NHTSA Recall No. 07V-363

RSB07-500-002

RECALL SERVICE BULLETIN

SUBJECT: Power Distribution – Bussmann® (DVEC) Dual Vehicle Electrical Center.

FIG. 2-1

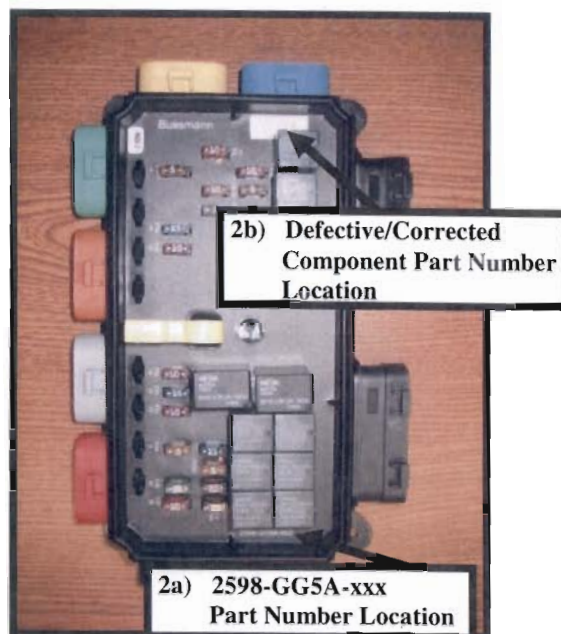
1. Observe all industry safety standards, disconnect any necessary power source and secure vehicle to allow for replacement of the Bussmann® DVEC at the rear PDC (Power Distribution Center).
2. Locate the rear PDC near the engine, generally on the passenger side between the rear wheels and the rear of the vehicle.
 - 2a. Refer to FIG. 2-1. Identify the DVEC having a part number beginning with 2598-GG5A. The part number is located on the inside cover and on the lower right inside face of the box.
 - 2b. Refer to FIG. 2-1, 2-2 & 3-1. The DVEC having a part number in the top right corner of the box ending in a -1 is defective and must be replaced with a box where this number ends in -2 as shown in FIG. 3-1.

FIG. 3-1

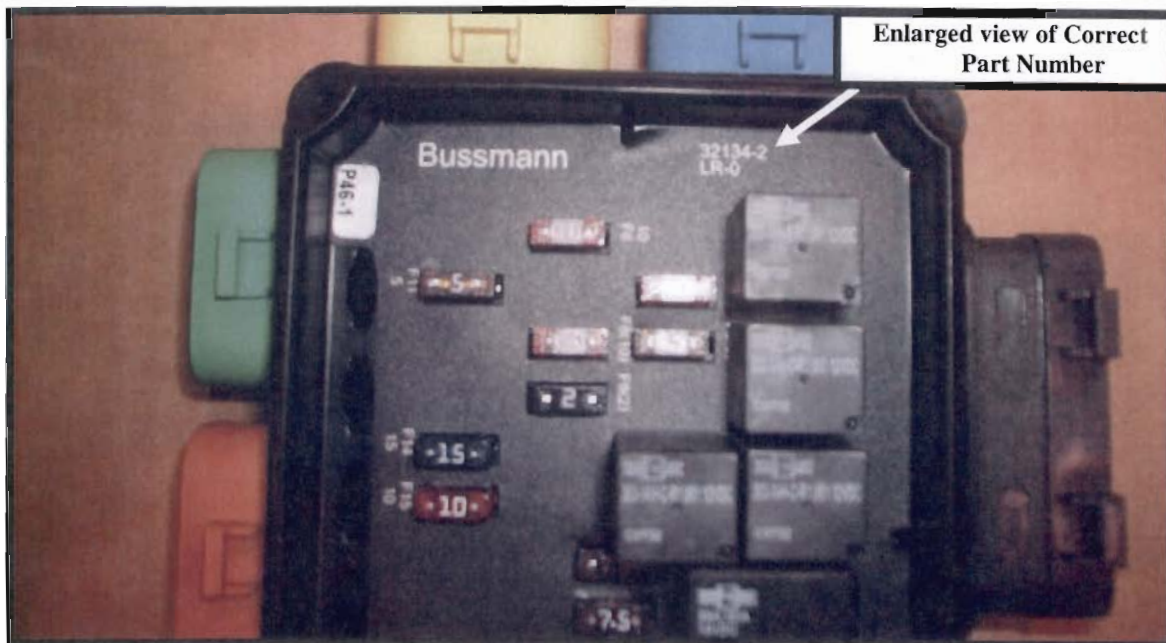
CAUSE: Loose jumper connection inside the Bussmann® DVEC

CORRECTION: Replace Bussmann® DVEC.

CORRECT BUSSMANN® DVEC SHOWN
